## **ADDENDUM “A”**

### **Request for Proposals RFP #08-0901**

#### **Construction of Solid Waste Convenience Site and Recycling Center**

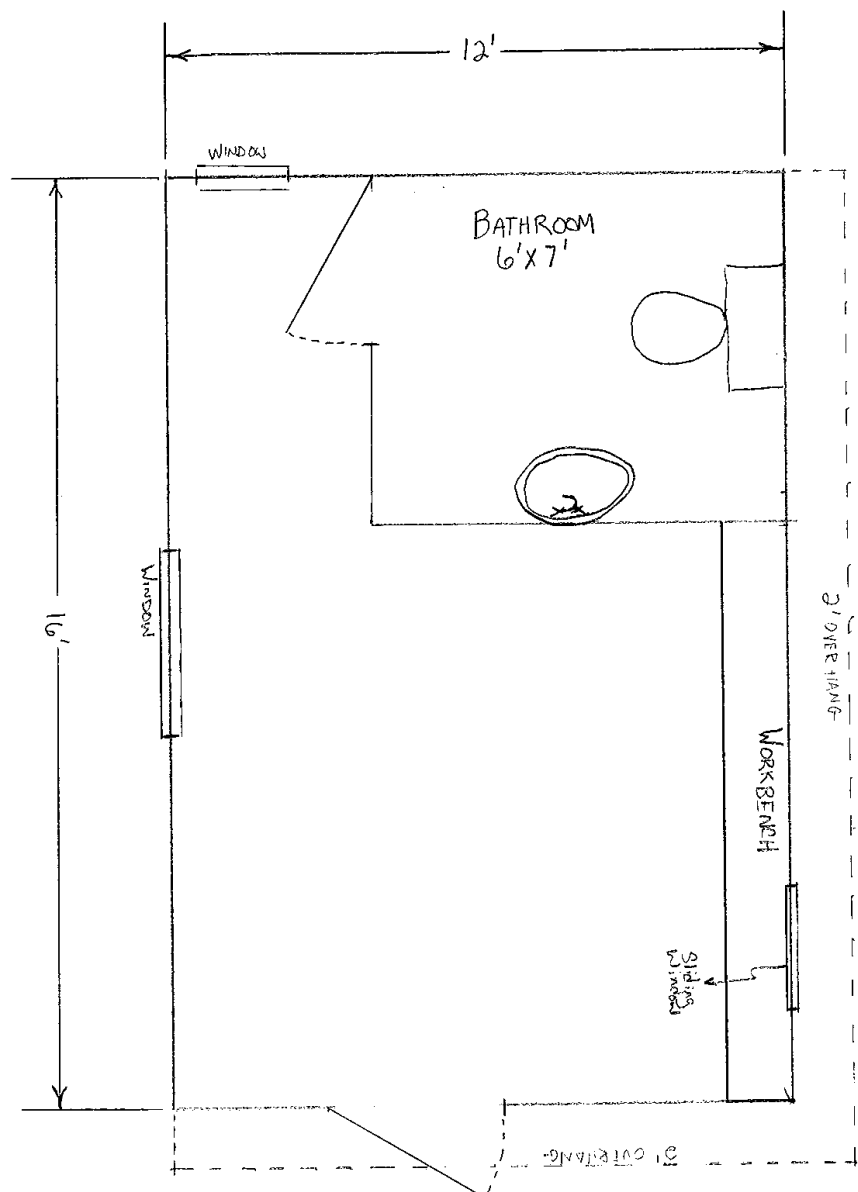
**QUESTION:** Is there a drawing or sketch of the layout for the guard house available?

**ANSWER:** Yes. See the following drawing showing the layout of the guard house being requested by Randolph County.
